Results of Agency Meeting to Discuss FPL Turkey Point T&E/Wildlife Protection Measures December 22, 2011

Agency Participants: BNP, FFWCC, PERA, USFWS

Recommended Protection Measures Related to Roadway Changes

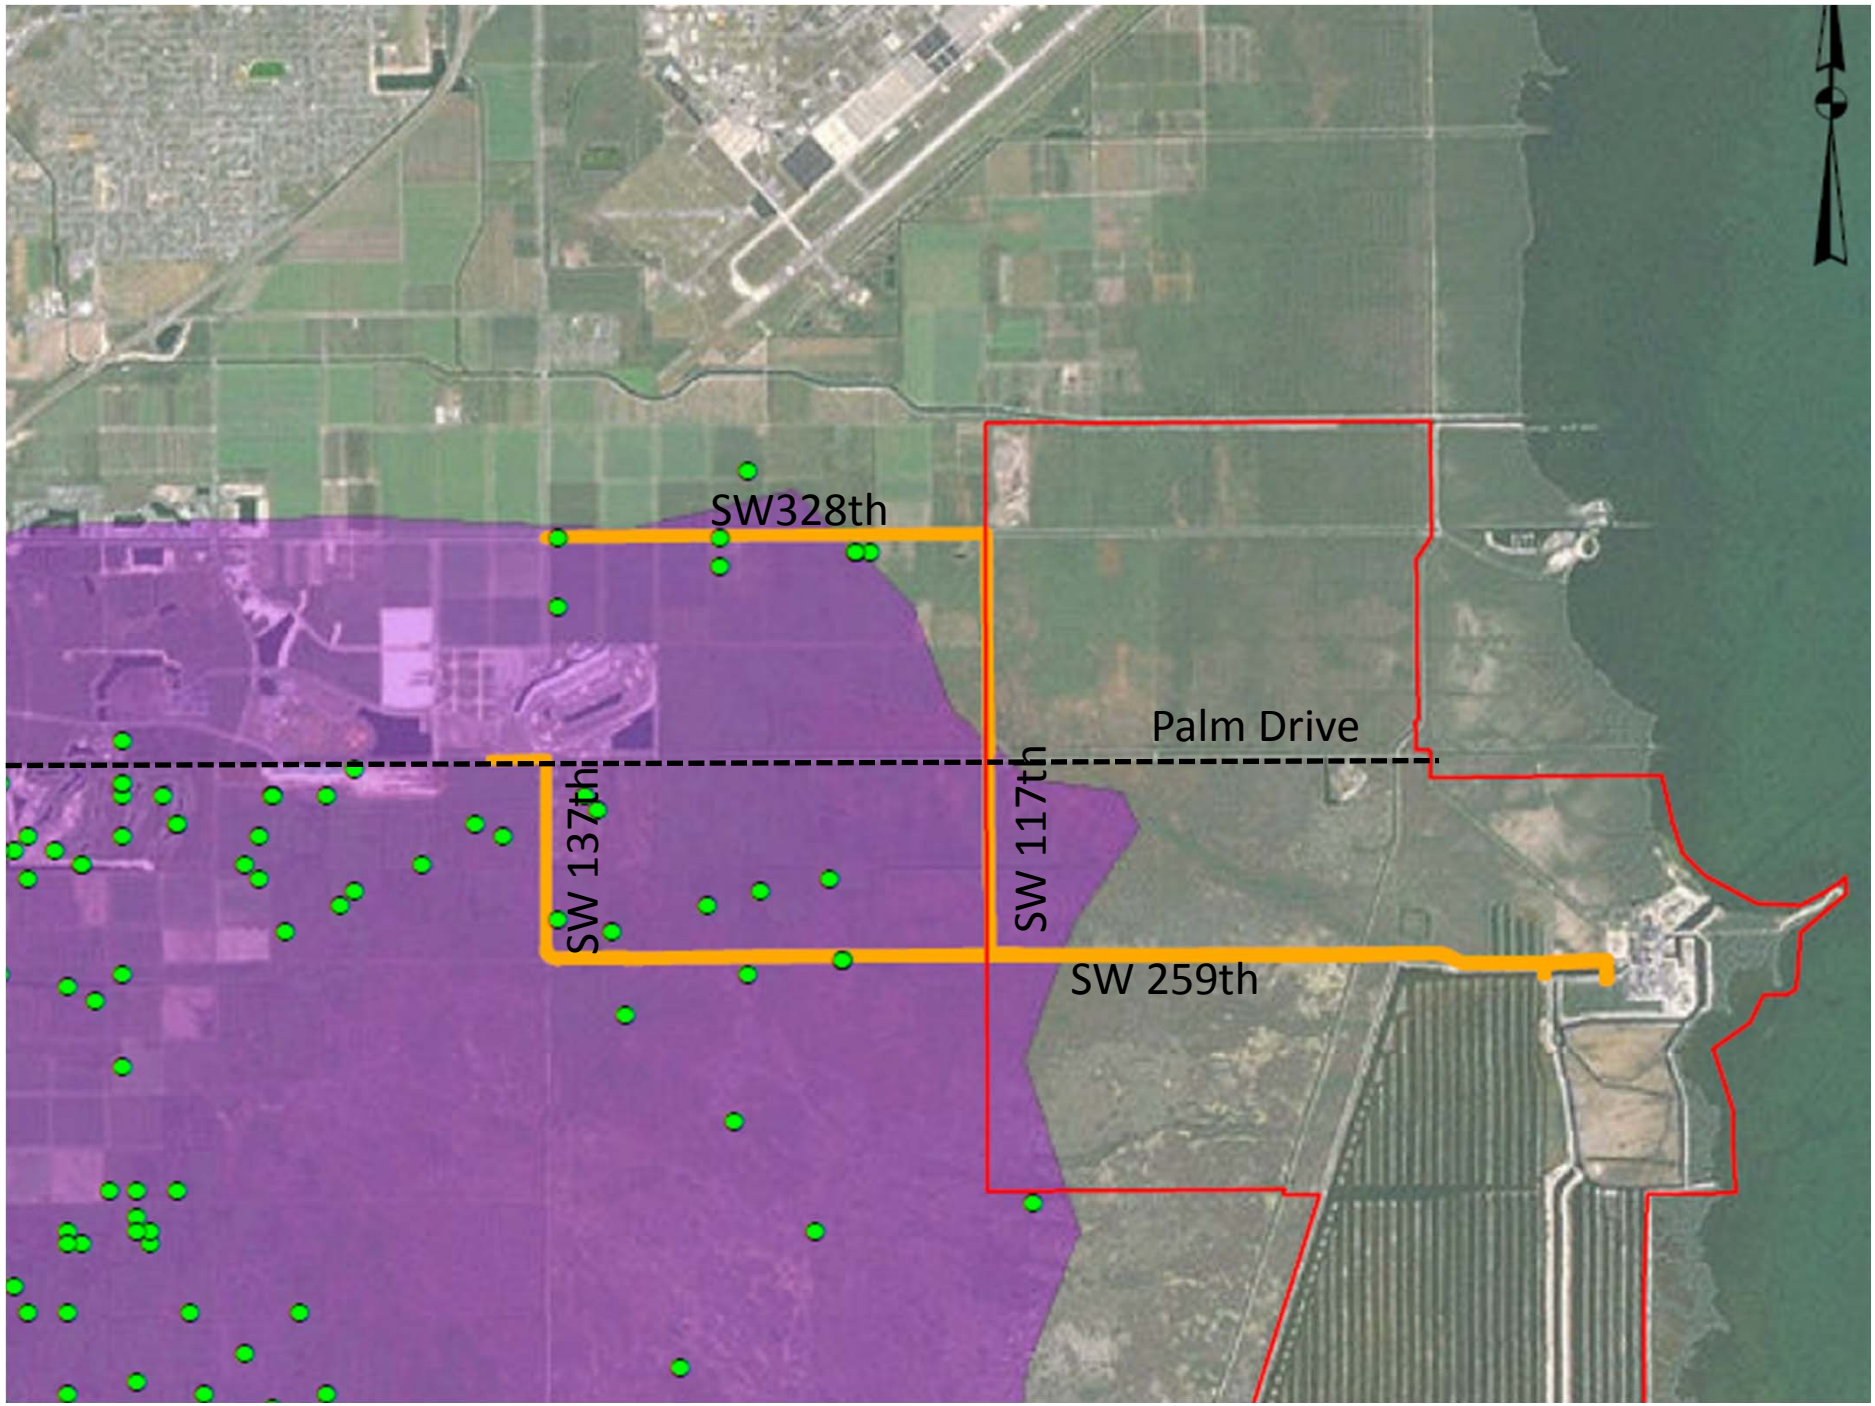
- 8 ft fencing plus herp fencing along full reach of SW259th
- 8 ft fence along SW117th and SW137th from SW359 to Palm Drive
- 2 large box culverts along SW359th; one at L-31E bridge
- Replace all existing culverts along 259th with larger oval culverts along SW359 and SW117/SW137 to Palm Drive

Other Protection Measures

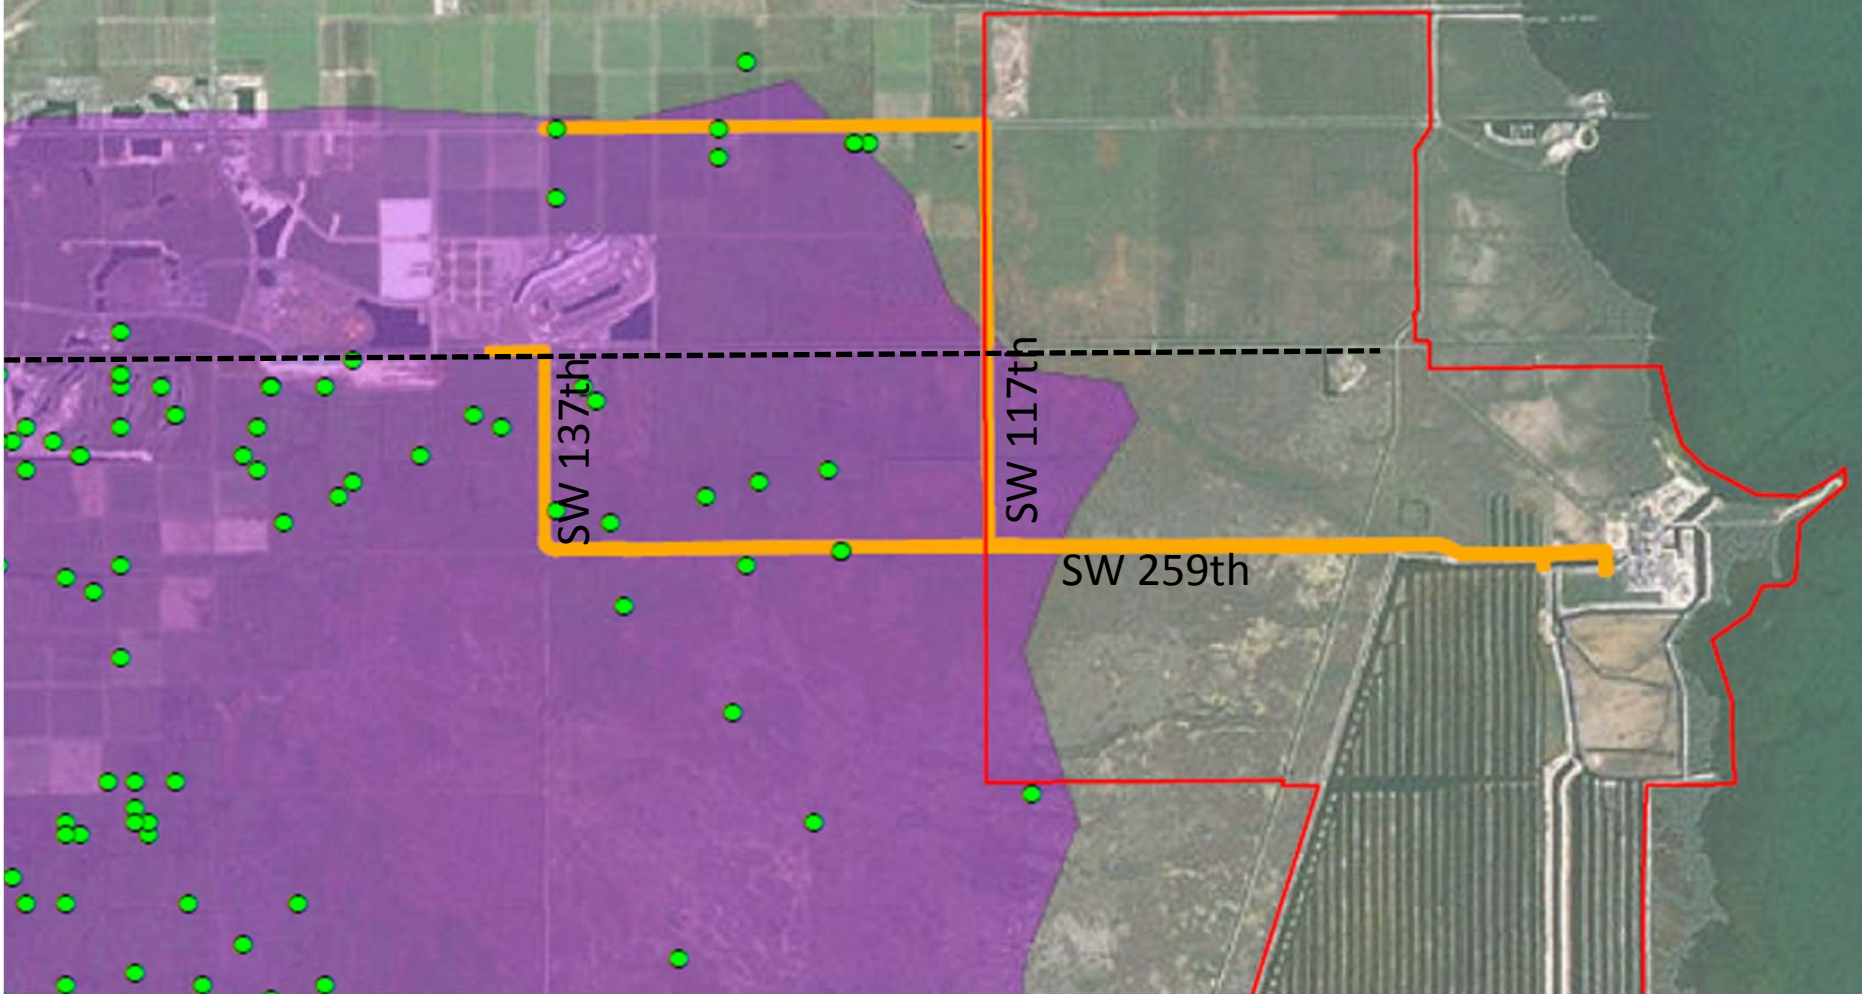
- Conduct a roadkill study along SW 328th to determine severity of problem
- And/or construct herp fencing along that roadway

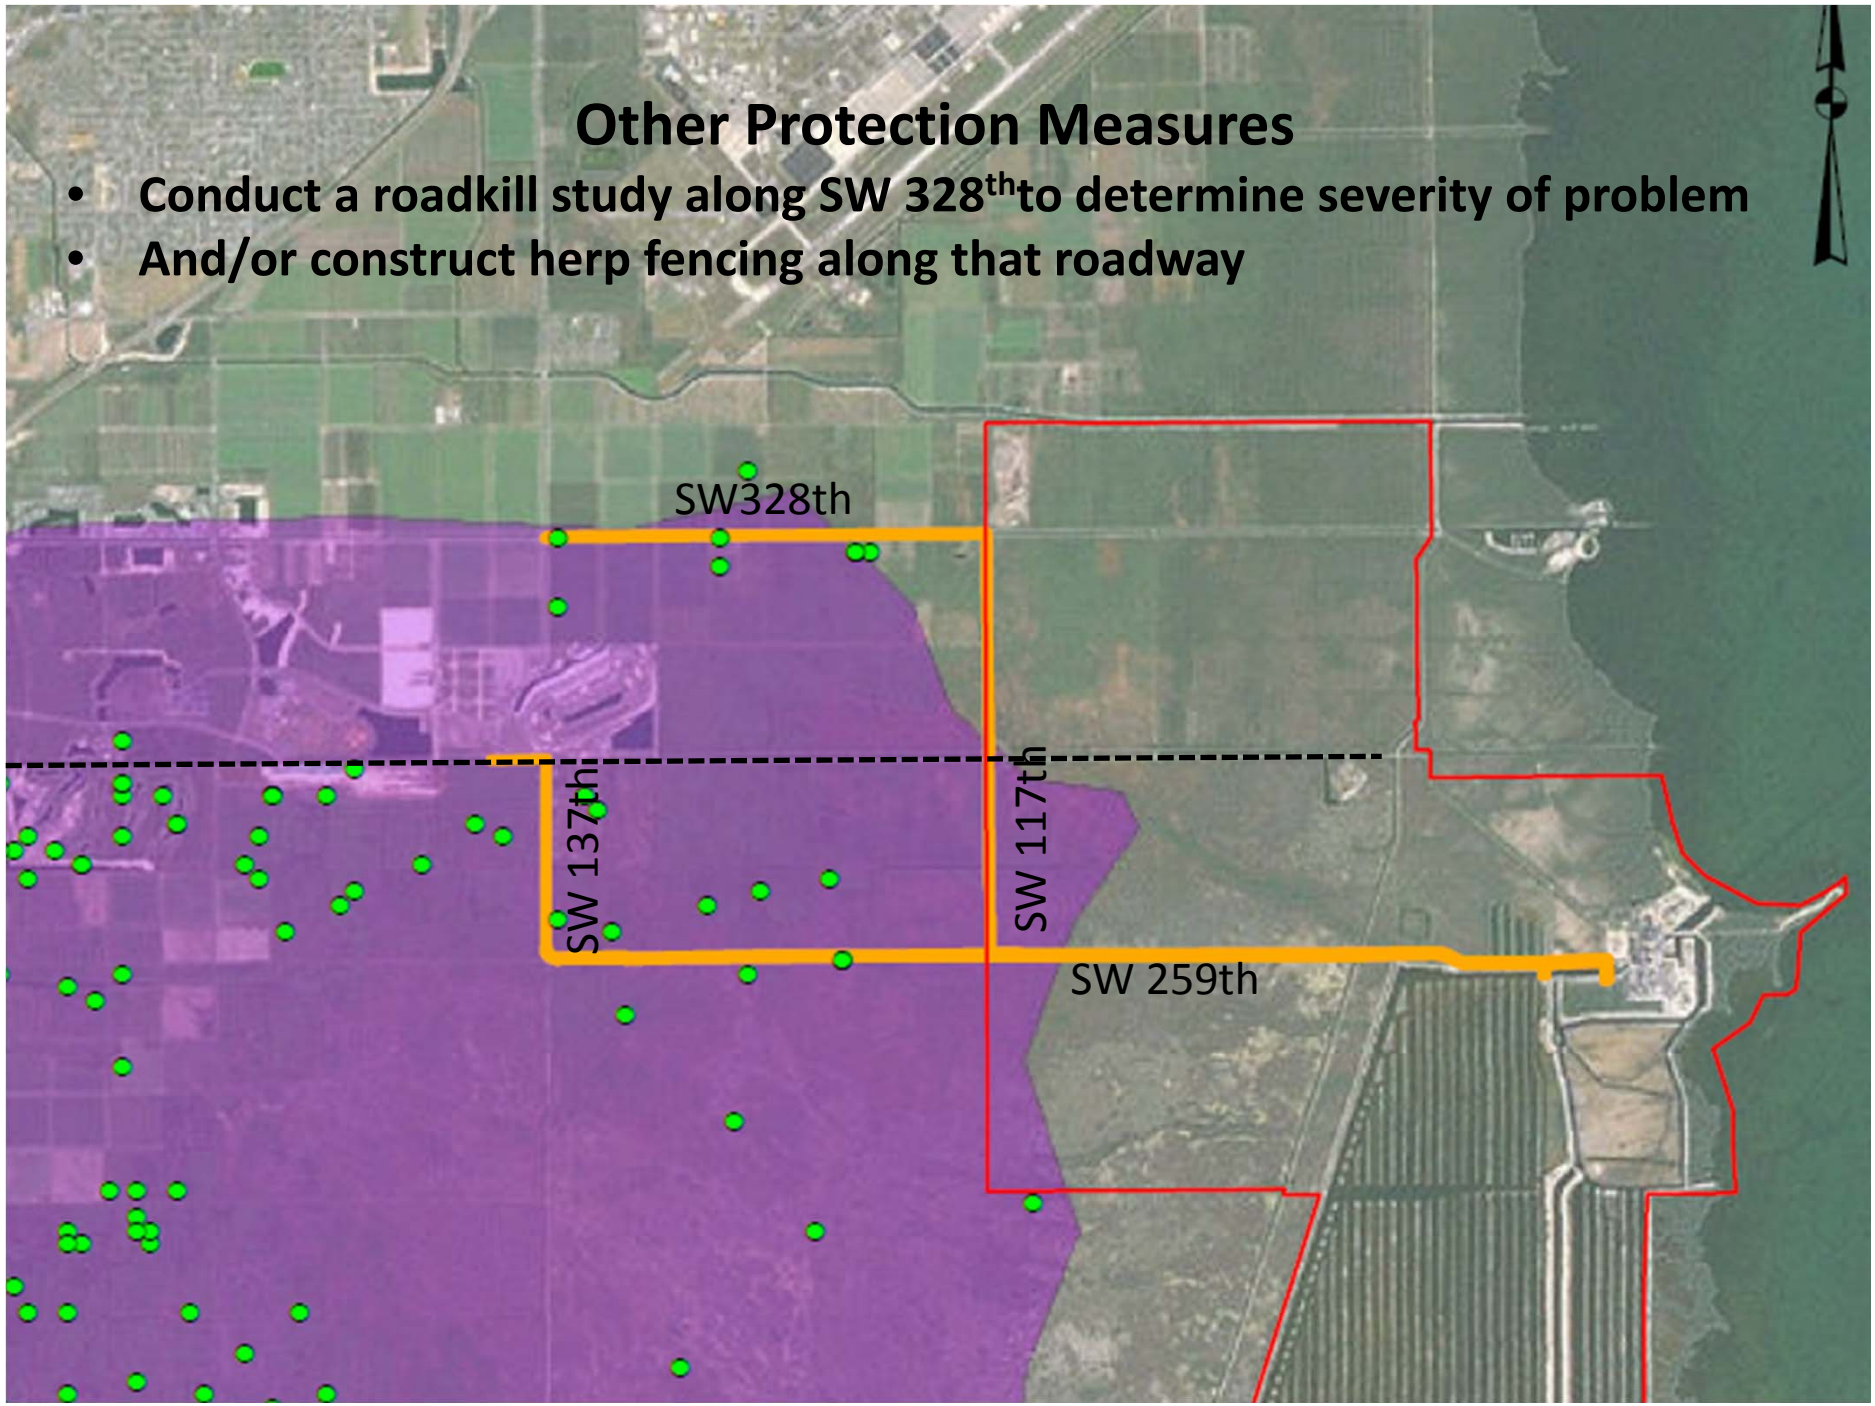
Recommending like-for-like compensation for loss of mud flat habitat.
